ACCESS REPORT

Alma

20 Albert Street, Freshwater

Reference No.
21011(DR)

Clause D3.3: Parts of building to be accessible

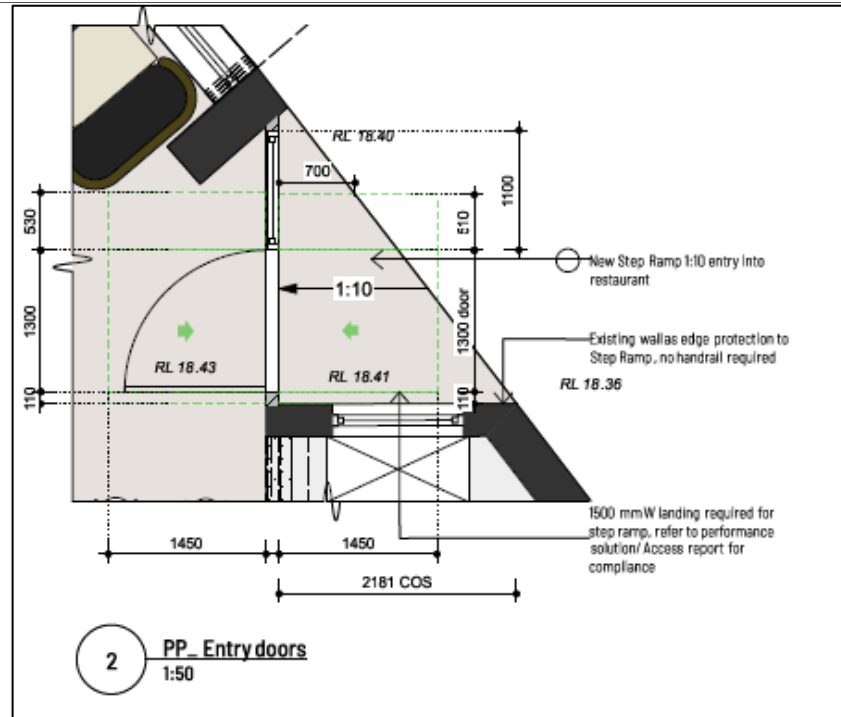
Compliance Status	
Design Detail	<p>New or existing ramps and stairs undergoing works are to accord with the provisions of Clause 10 and 11 of AS1428.1-2009.</p> <p>Compliance generally indicated. Following considerations to form part of the design documentation at the relevant phase;</p> <ul style="list-style-type: none"> - The front entry door is indicated as having a 1:10 step ramp leading directly to it without the required 1500mm deep landing. Detailing required to determine suitable options in regards to falls / crossfalls where the ramp meets the property boundary. <p>We understand it is the intention to have this matter addressed by <i>Performance Solution</i> to negate the need for a landing subject to further detailing and discussions by placing reliance on either an automated door or a suitable management plan.</p>

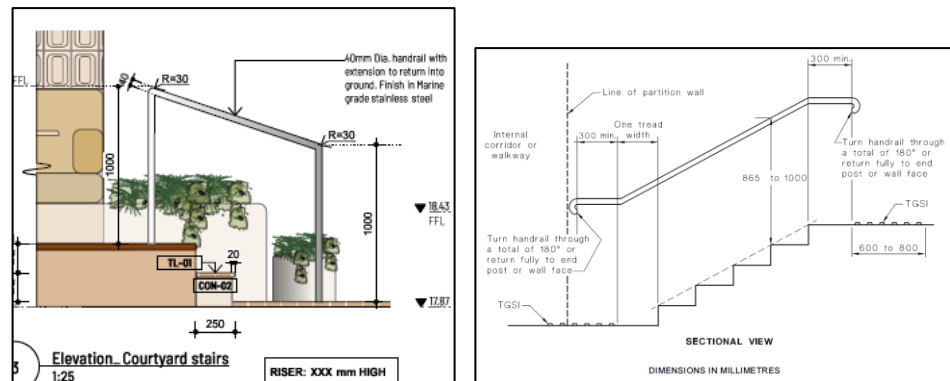
- The two sets of stairs are to have compliant handrails with projections and extensions noting that the bottom handrails are to extend 1x tread plus 300mm projection plus termination, all inside the property boundary.

Noting below, the 300mm projection to top and bottom landing must be parallel to the landing, with the 300mm measured between transition points and excluding the termination component.
